TIBET ROAD (TRIBUTARY T TO E. 48TH AVE.) AMENDMENT 2  
SITE PLAN FOR INFRASTRUCTURE  
TITLE: LANDSCAPE PLAN  
DATE: September 17, 2024

TIBET ROAD (TRIBUTARY T TO E. 48TH AVE.) AMENDMENT 2  
SITE PLAN FOR INFRASTRUCTURE  
TITLE: LANDSCAPE DETAILS  
DATE: September 17, 2024

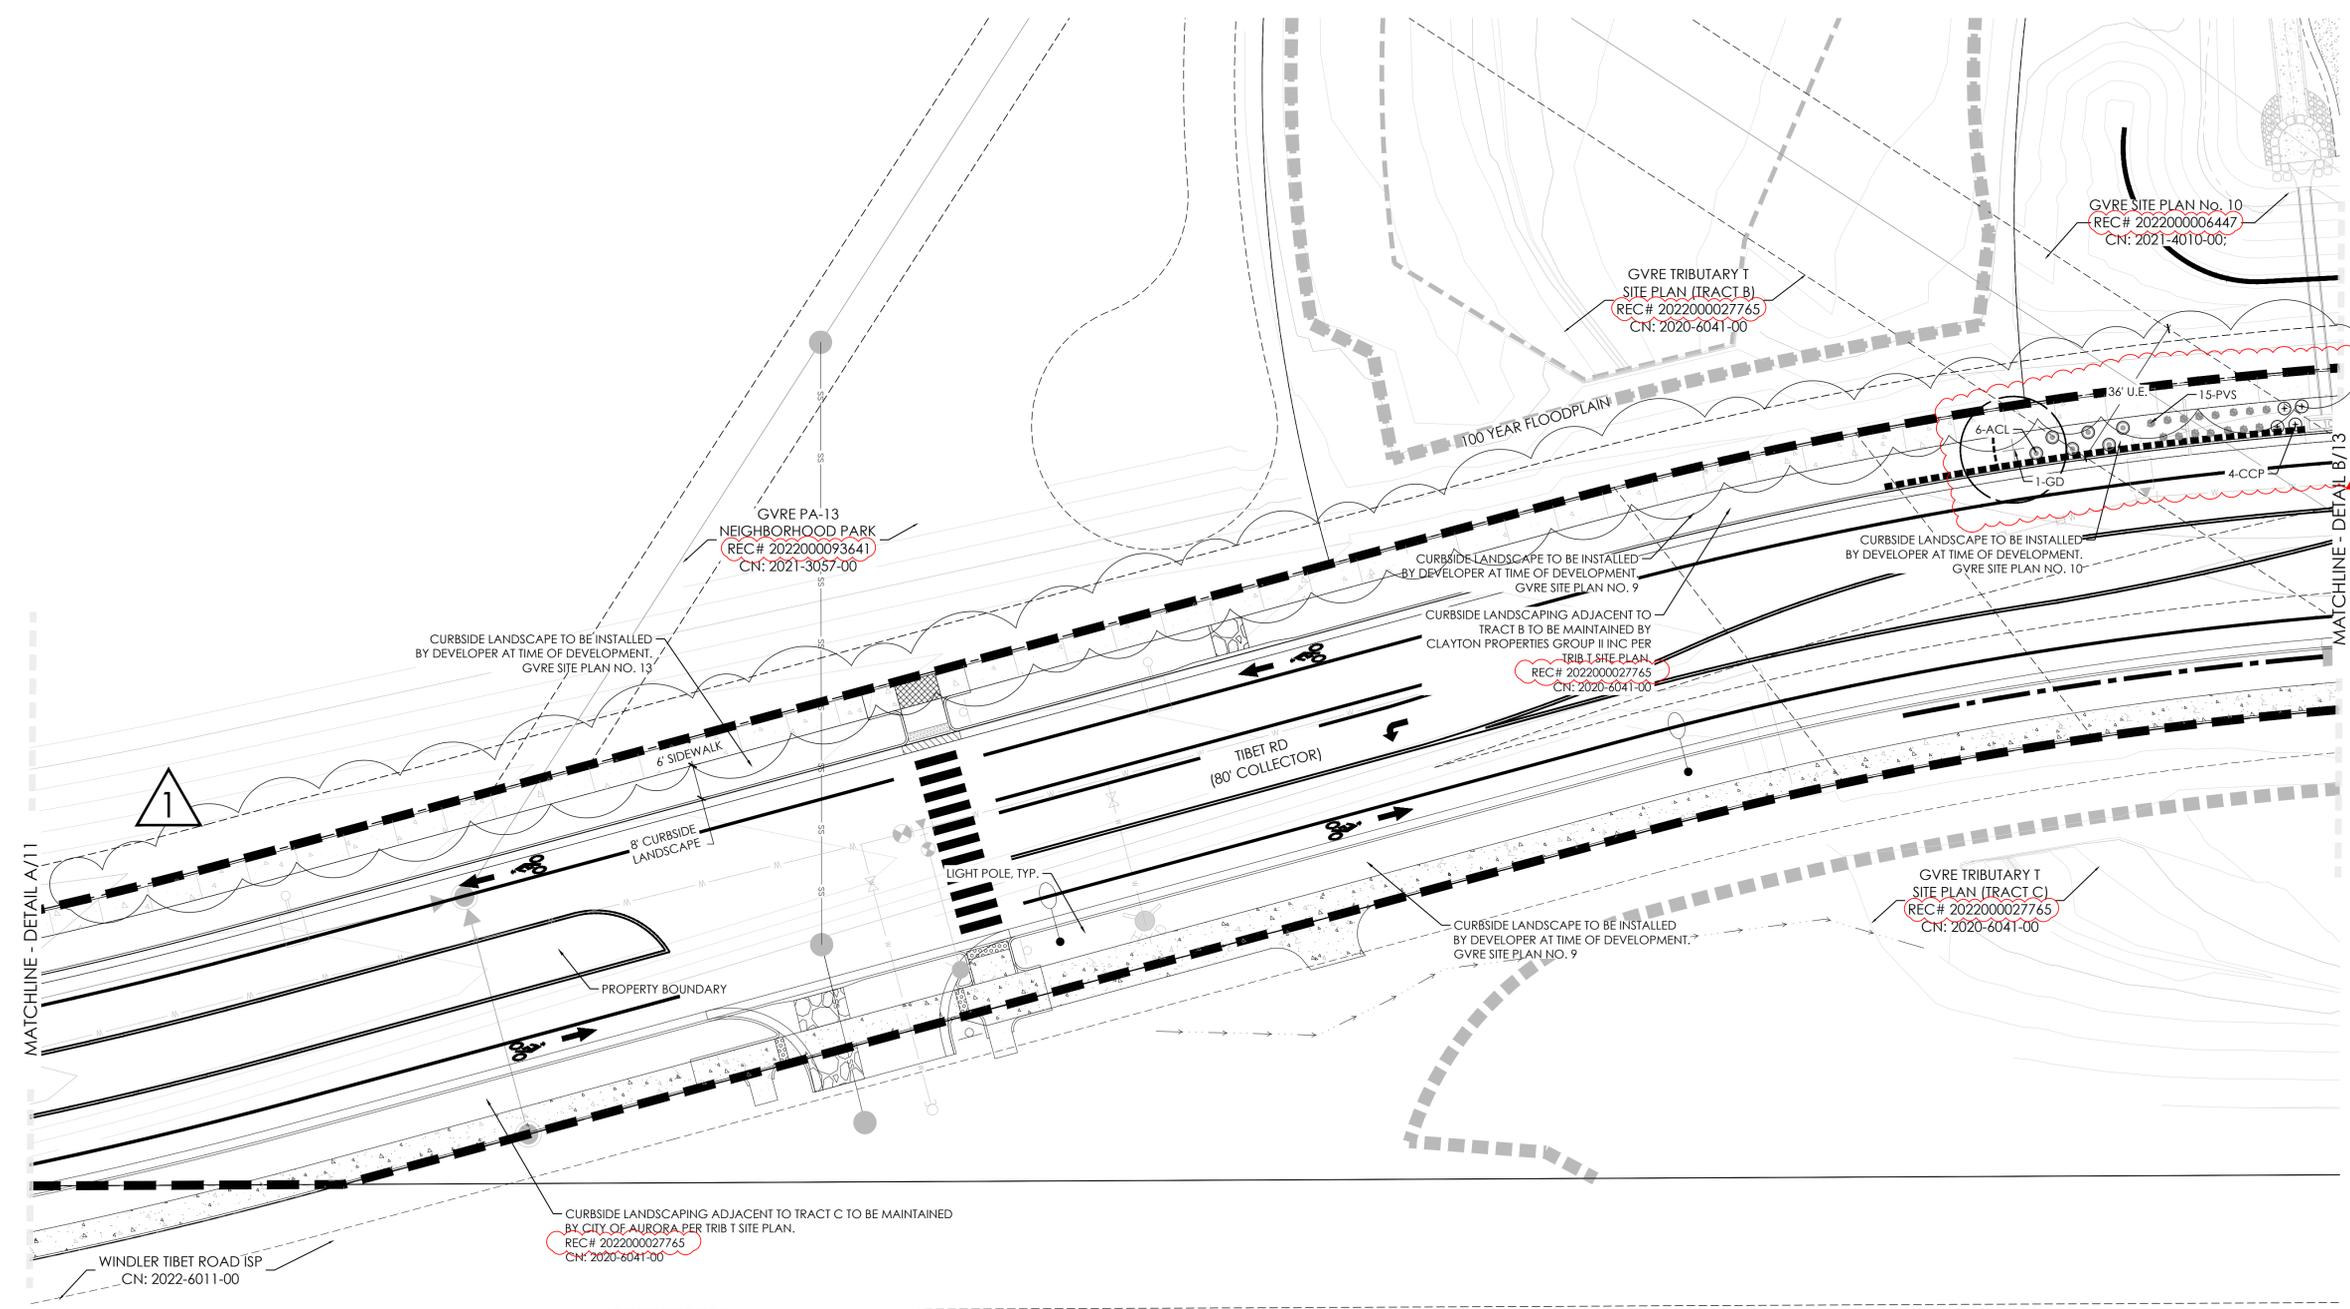
**1**  
AMENDMENT 1  
- REMOVE CRUSHER FINES BIKE PATH

**2**  
AMENDMENT 2  
- PLANTING REVISED  
- RECEPTION NUMBERS ADDED

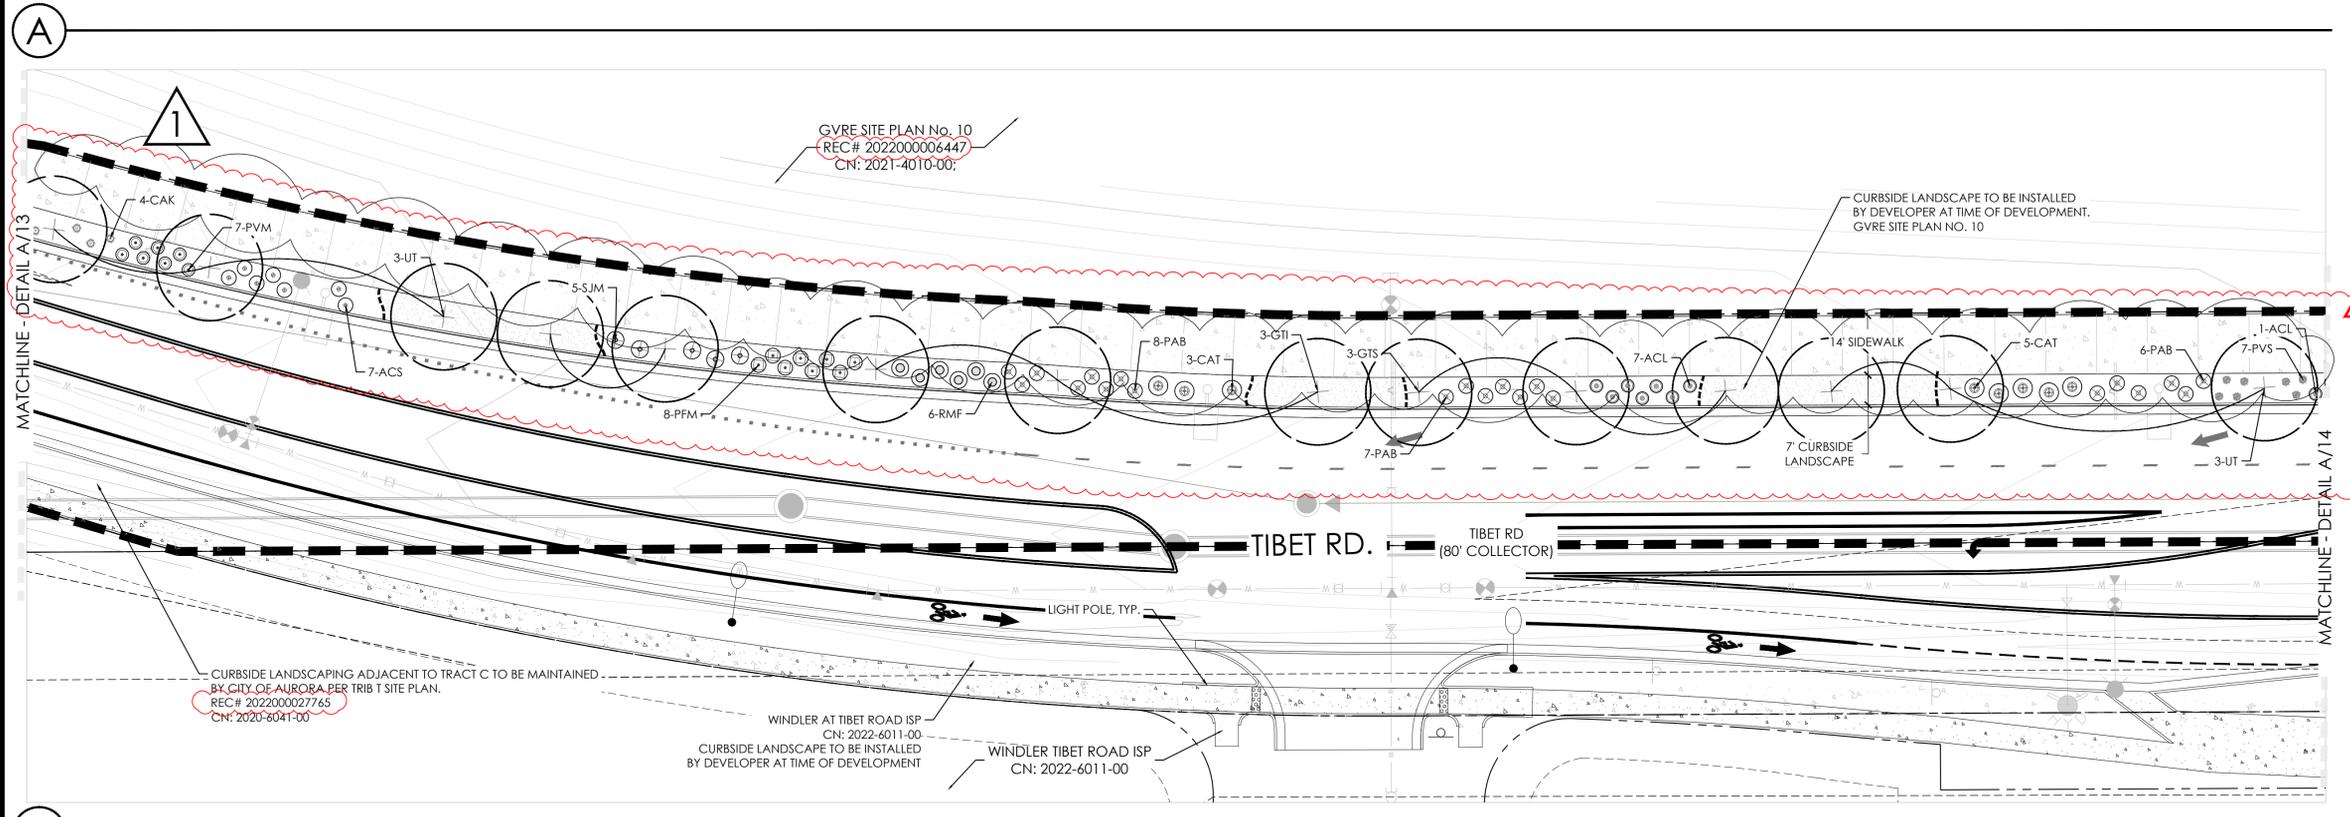
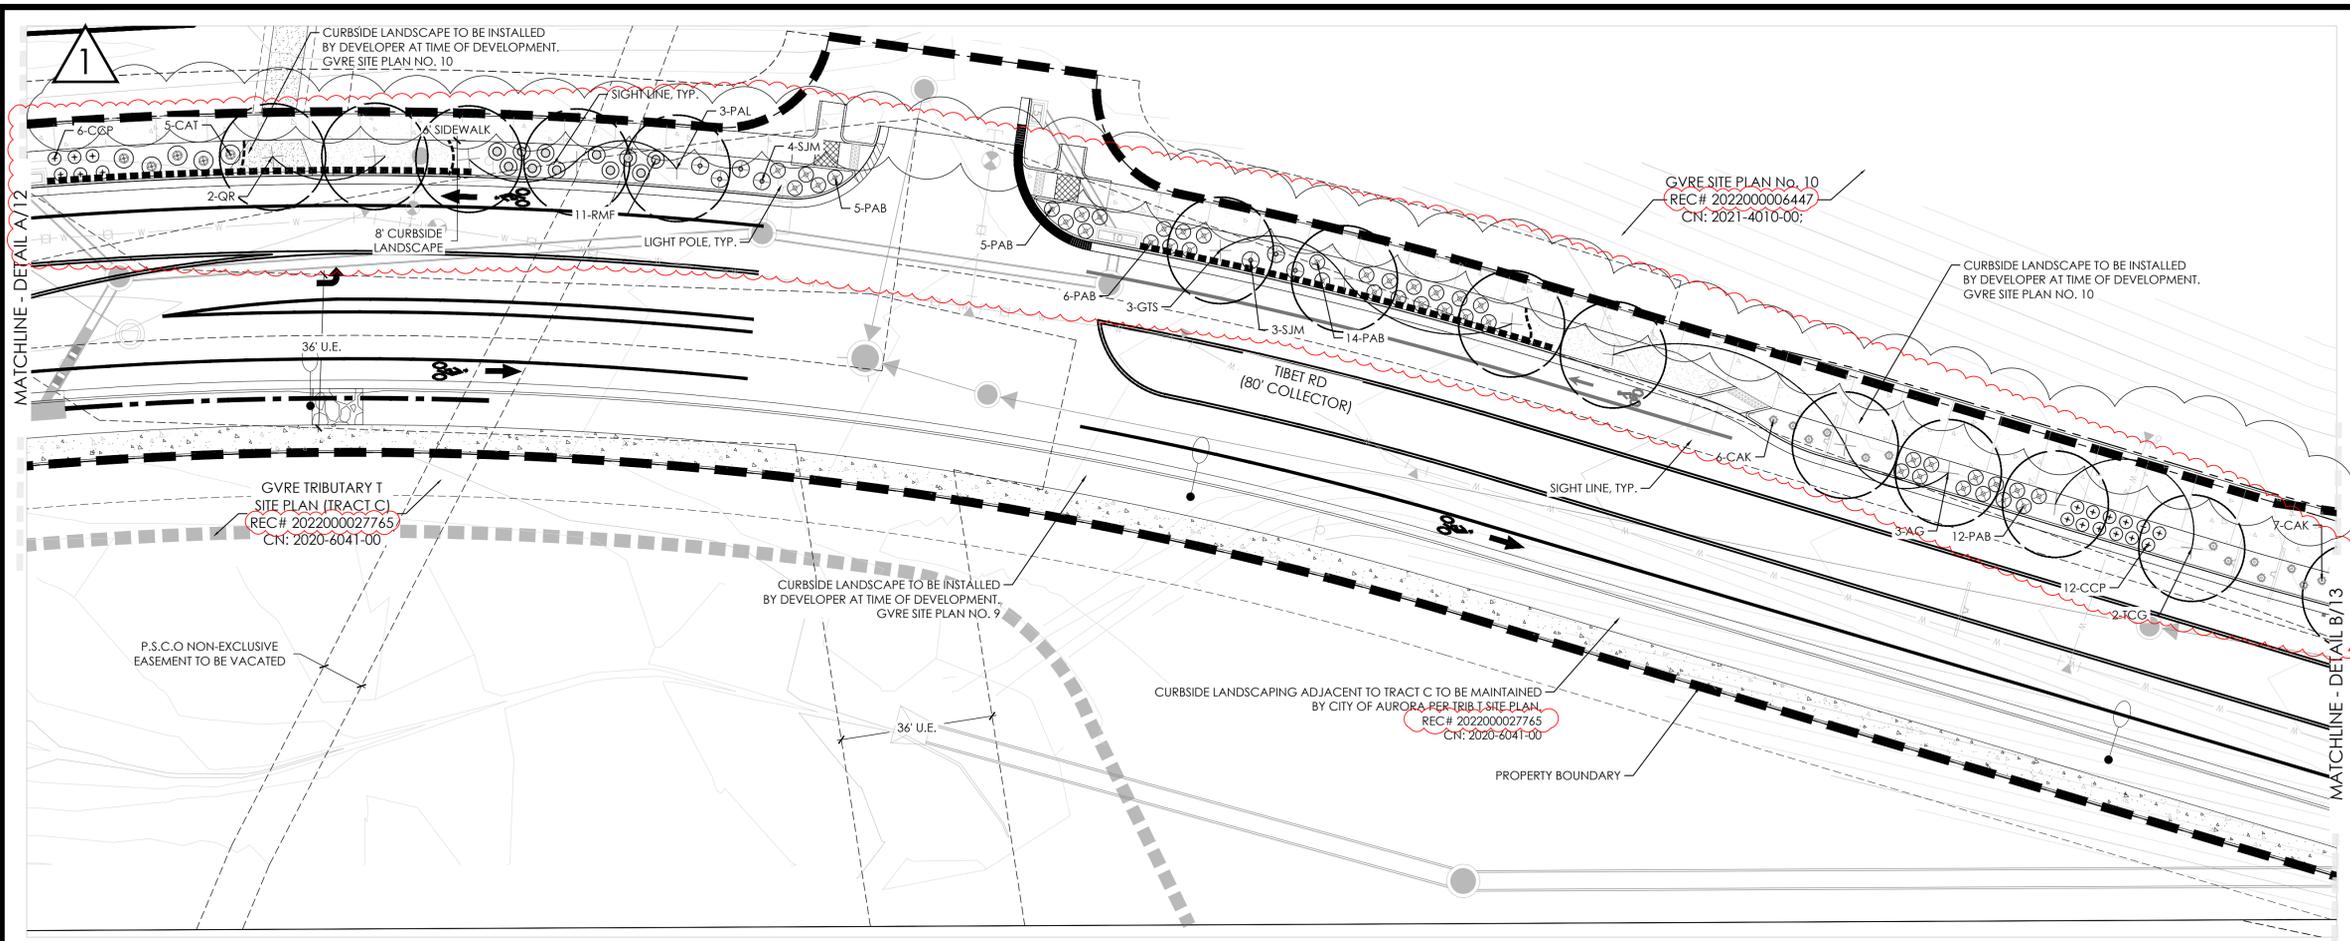
**1**  
AMENDMENT 1  
- REMOVE CRUSHER FINES BIKE PATH

**2**  
AMENDMENT 2  
- PLANTING REVISED  
- REMOVED ACCESS POINT INTO GvRE FILING 10  
- ADDED AN ADDITIONAL TRAVEL LANE ON THE WEST SIDE OF TIBET ROAD  
- BIKE LANE COMBINED WITH SIDEWALK TO MAKE A 14' SHARED WALK  
- RECEPTION NUMBERS ADDED

TIBET ROAD (TRIBUTARY T TO E. 48TH AVE.) AMENDMENT 2  
 SITE PLAN FOR INFRASTRUCTURE  
 TITLE: LANDSCAPE PLAN  
 DATE: September 17, 2024

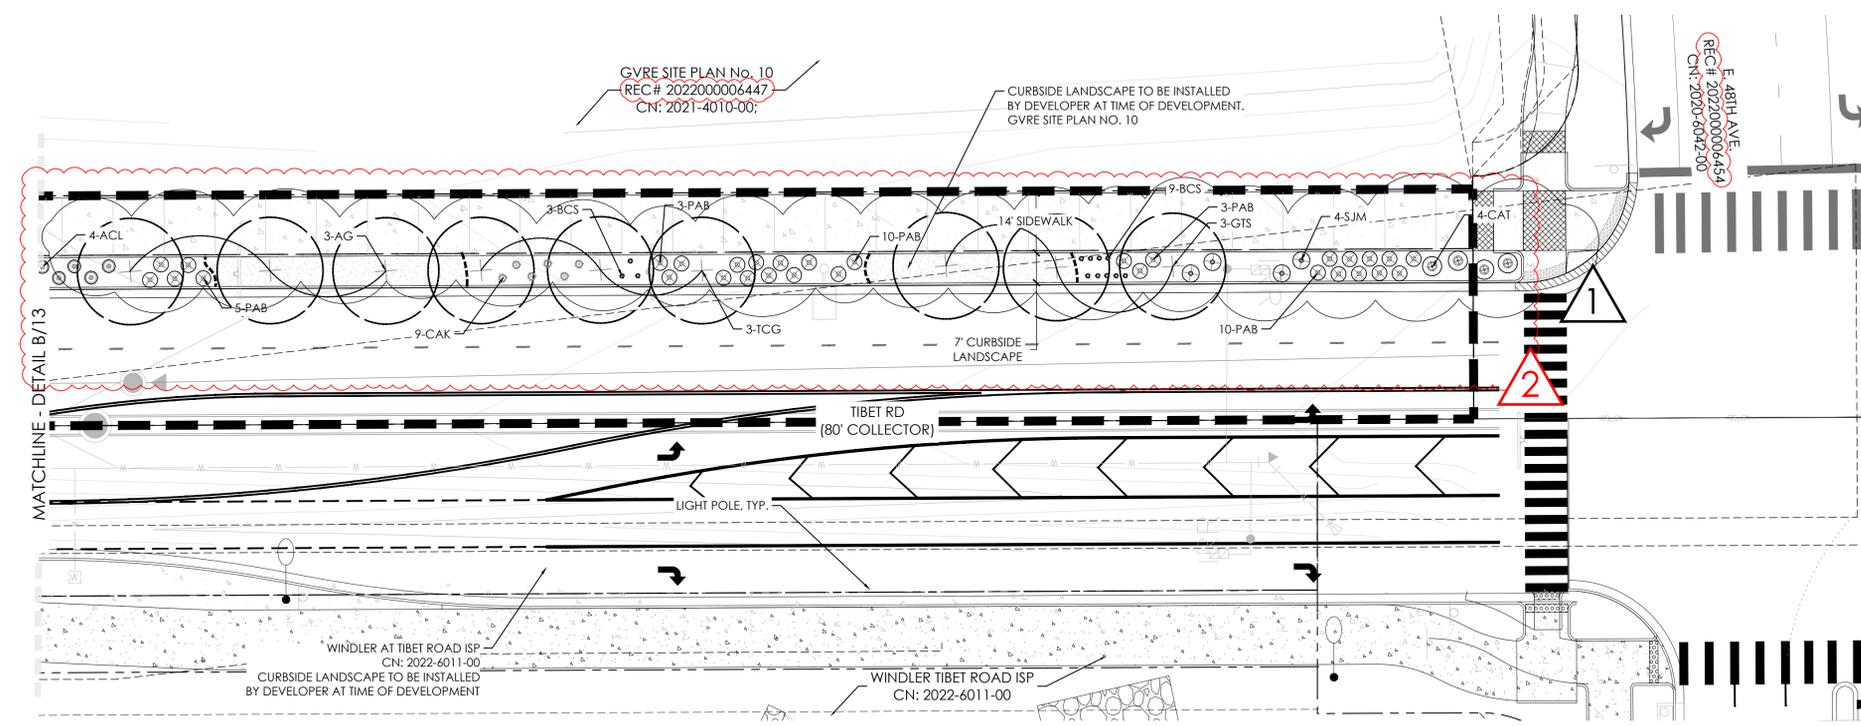
**1**  
 AMENDMENT 1  
 - REMOVE CRUSHER FINES BIKE PATH

**2**  
 AMENDMENT 2  
 - PLANTING REVISED  
 - REMOVED ACCESS POINT INTO GVR FILING 10  
 - ADDED AN ADDITIONAL TRAVEL LANE ON THE WEST SIDE OF TIBET ROAD  
 - BIKE LANE COMBINED WITH SIDEWALK TO MAKE A 14' SHARED WALK  
 - RECEPTION NUMBERS ADDED

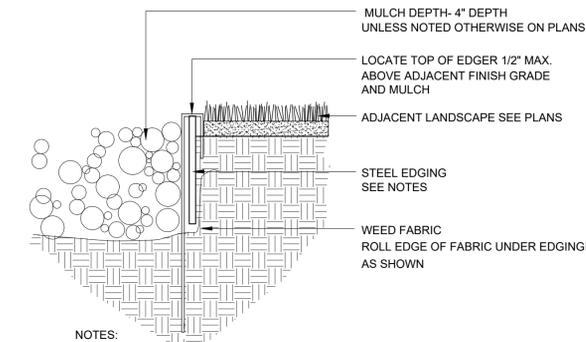
**1 AMENDMENT 1**

- UPDATED PLANT QUANTITIES
- ADDED EAST SIDE OF TIBET TO CURBSIDE LANDSCAPE REQUIREMENTS
- MOVED DETAILS FROM SHEET 15 TO THIS SHEET
- REVISED CURBSIDE LANDSCAPE REQUIREMENTS

**2 AMENDMENT 2**

- REVISED CURBSIDE LANDSCAPE REQUIREMENTS ALONG WEST SIDE OF TIBET RD.
- PLANT QUANTITIES REVISED

3 CRUSHER FINES BIKE PATH  
SCALE: NTS

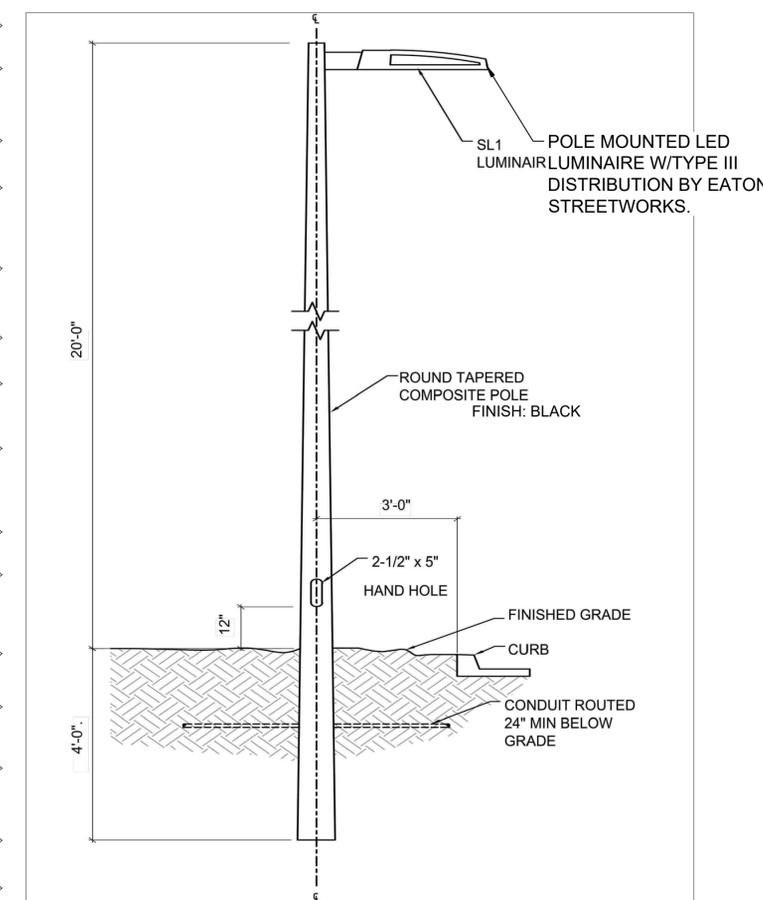
1 AMENDMENT 1  
- REMOVE CRUSHER FINES BIKE PATH  
- MOVED DETAILS TO SHEET 14  
- ADDED STREET LIGHT DETAILS
